Newfoundland and Labrador Bird Colony Buffer Analysis

Product Objective

Figure 1. Colony locations with 5 km colony buffer, separate 10 km coastal buffer, and offshore wind energy development licencing areas as currently defined within the NL Draft Final Report. The dashed black line represents a 28 km buffer, and the solid black line

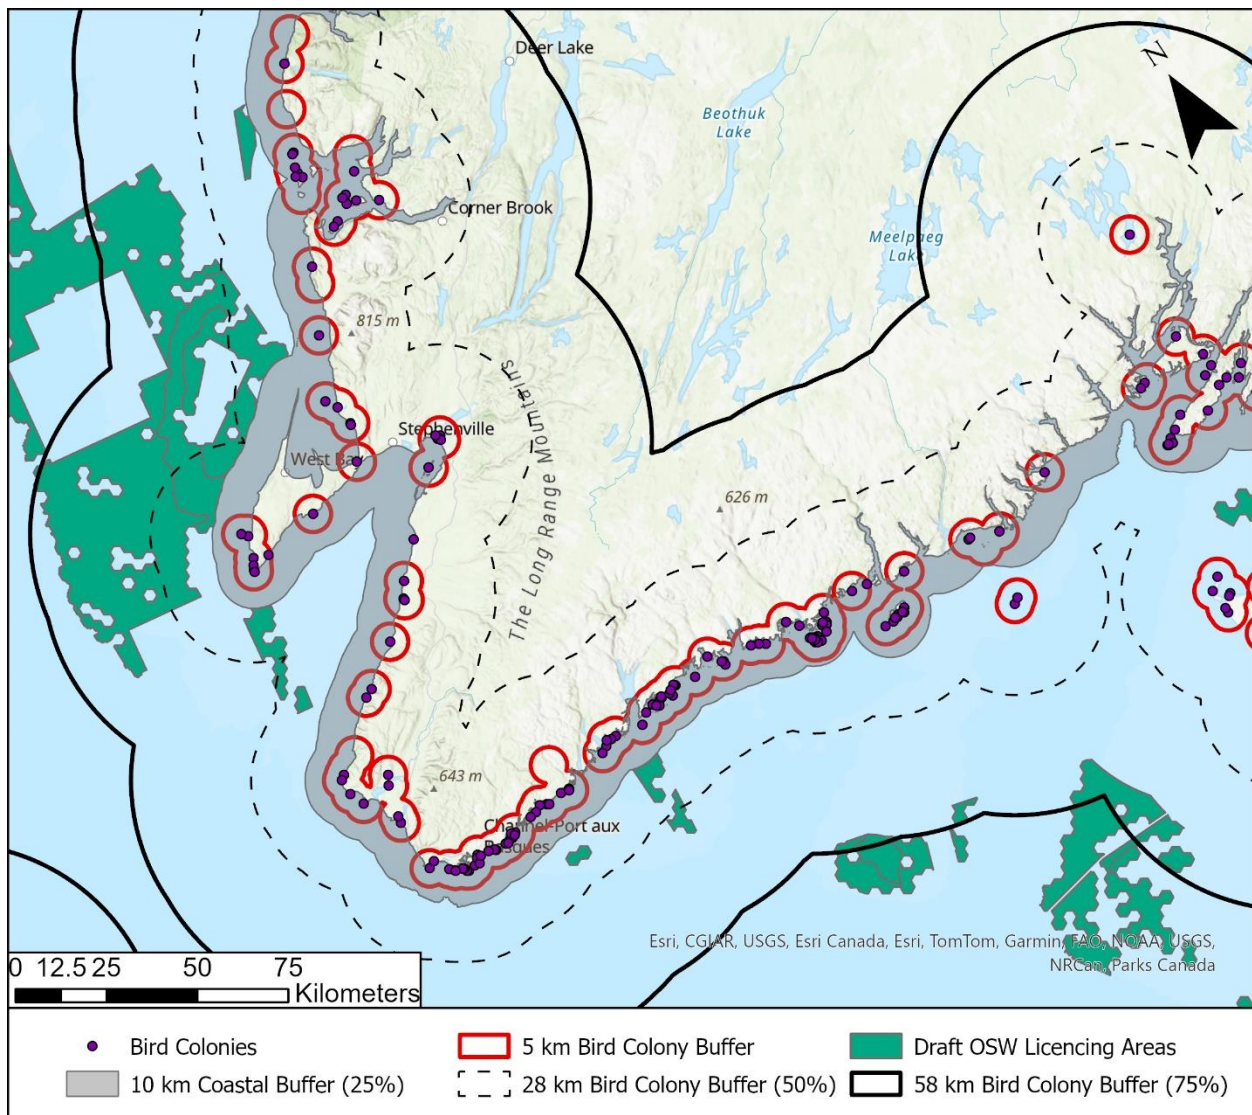
Committee for the Regional Assessment on OWED has recommended a 10 km coastal buffer with the addition of a 5 km buffer around known breeding bird colonies (Figure 1). In all scenarios, the 10 km coastal buffer recommended by the NL RA Committee was included and maintained as described in the Draft Final Report. Therefore, the scenario with the 0 km bird colony buffer only includes the 10 km coastal buffer around coastal colonies and provides the baseline conditions for comparison. To demonstrate the importance of colony buffers in addition to the coastal buffer, applied buffers ranged from 0 – 60 km, increased at intervals of 5 km. Any overlapping colony buffer boundaries were dissolved and merged before extracting bird abundance estimates.

Implementing larger minimum buffers around bird colonies will help avoid and minimize impacts from future offshore wind energy development in Newfoundland and Labrador. ECCC recommends increasing the proposed minimum buffer from 5km

to better mitigate impacts to foraging colonial birds during their breeding seasons. For project-level environmental assessments, proponents should consult with ECCC for additional guidance. For Leach's storm-petrel, and any other far-ranging species including Manx Shearwater, proponents should consult with ECCC for additional guidance.
